Attention Director Infrastructure Projects, Planning Services, Department of Planning and Environment GPO Box 39, Sydney, NSW, 2001	Name: C. CROWLEY
	Address: 281 BELMONT ST
Application Number: SSI 7485	Suburb: ALEXANDRIA Postcode 2015
Application Name: WestConnex M4-M5 Link	Signature: <i>C. Crowley</i>
Please <u>include / delete (cross out or circle)</u> my personal information when publishing this submission to your website Declaration: I <u>HAVE NOT</u> made any reportable political donations in the last 2 years.

I object to the whole of the WestConnex Project, and the specific WestConnex M4-M5 Link proposals as contained in the EIS M4/M5 Application, for the following reasons:

The EIS states in 6.5.8 Darley Road civil and tunnel site (C4) that:

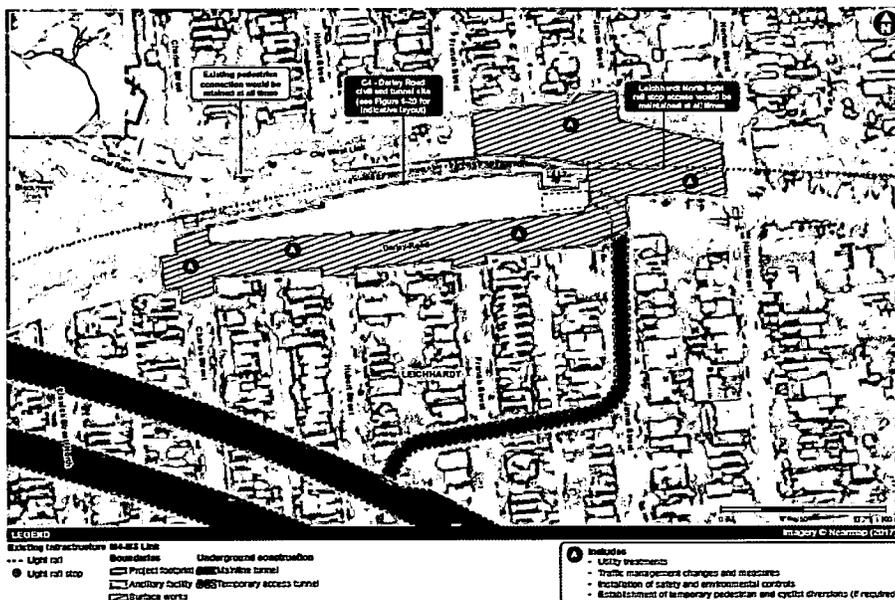
1. I object to the EIS because it fails to describe the temporary changes to Darley Road, Leichhardt to enable access to and from the ancillary facility that would likely be required in relation to the Darley Rd site and instead allows for the final plan to be decided by the contractor.

It is not clear how continued access, pedestrian and cyclist movement will be preserved and I am concerned that the impacts have not been correctly identified and assessed by the proponent.
